SITE SUPPLEMENTAL INSTRUCTION

PROJECT: Forestside Estates
Attmar & Palleschi Drive
Brampton, Ontario

SITE INSTRUCTION NO. E-1

SITE SI NO. E-2

TITLE	PARKING LEVEL PART A ELECTRICAL
PROJECT	BRAMPTON STACKED FORESTSIDE ESTATES
DRAWN	SP
CHECKED	MG
SCALE	1:100
DATE	MAY, 2019
PROJECT	18-017
DRAWING	E-2A
OF	16

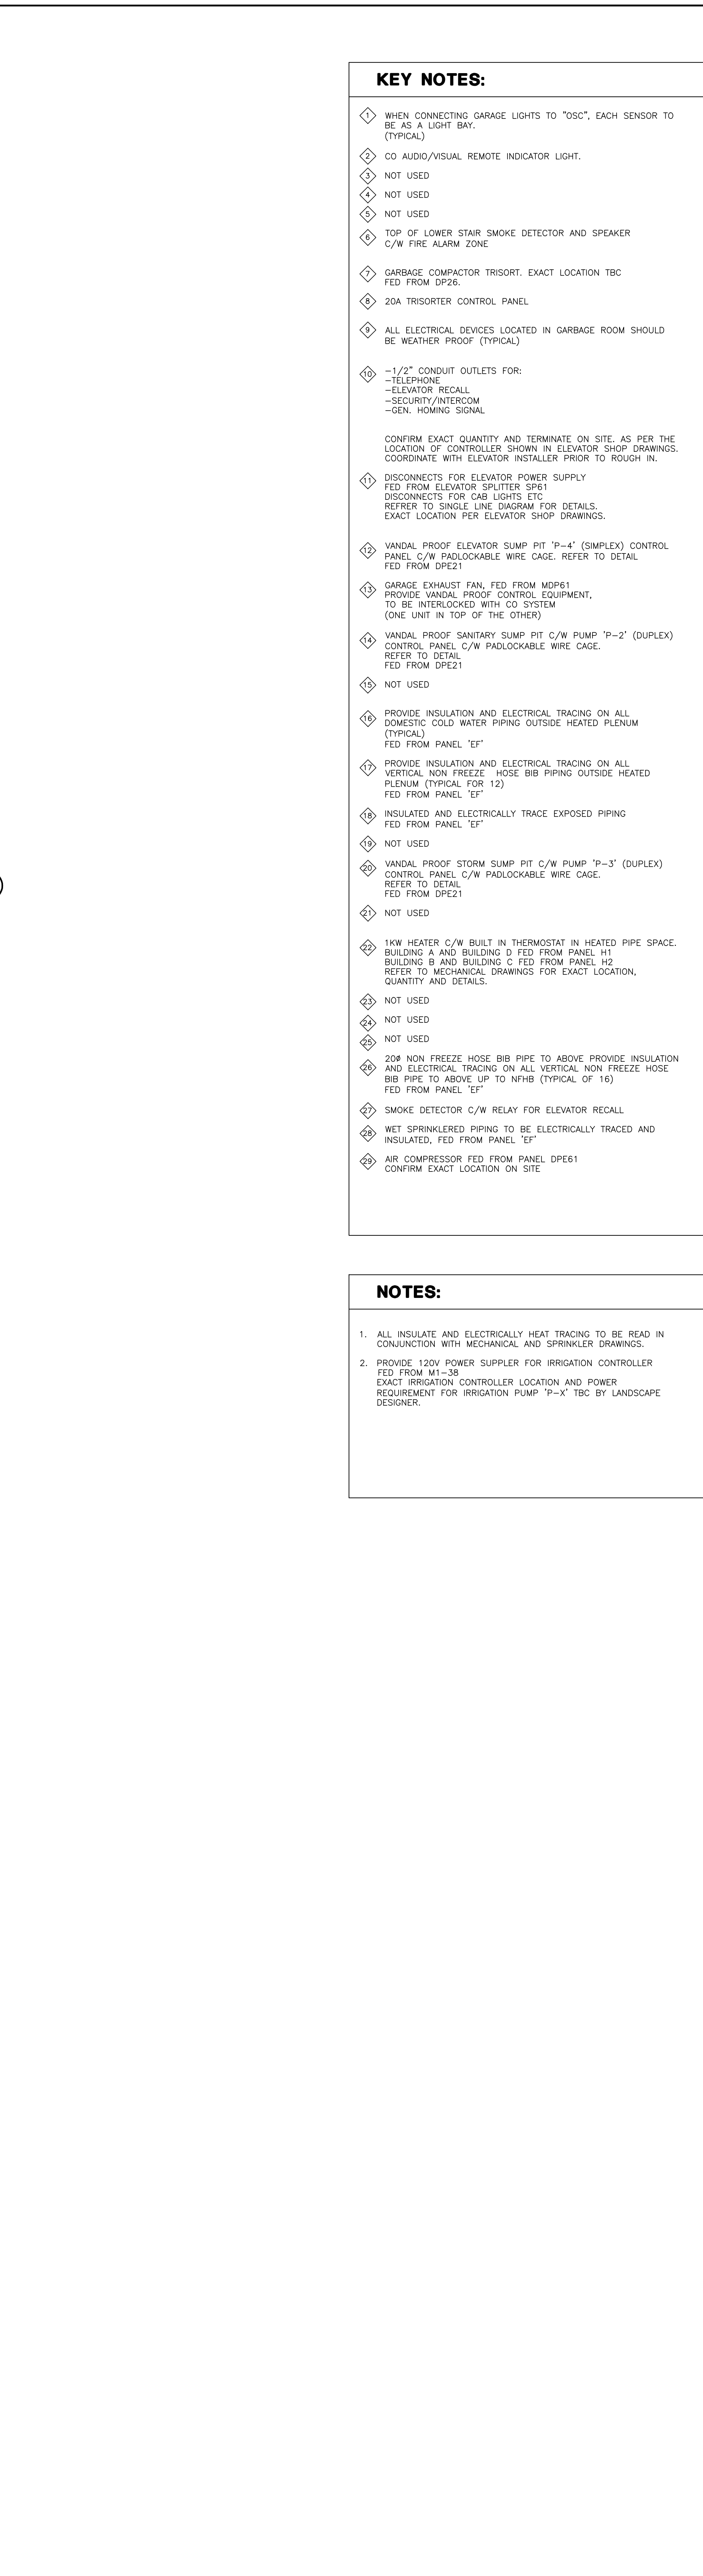
1.0 Reference Drawings E-2A/2B (Parking Level - Electrical) Issued

- 1.1 Revise: To note one exhaust fan F-5 run continuously as shown.
- 1.2 Add: Notes 'refer to mechanical fan schedule for fans run continuously'.
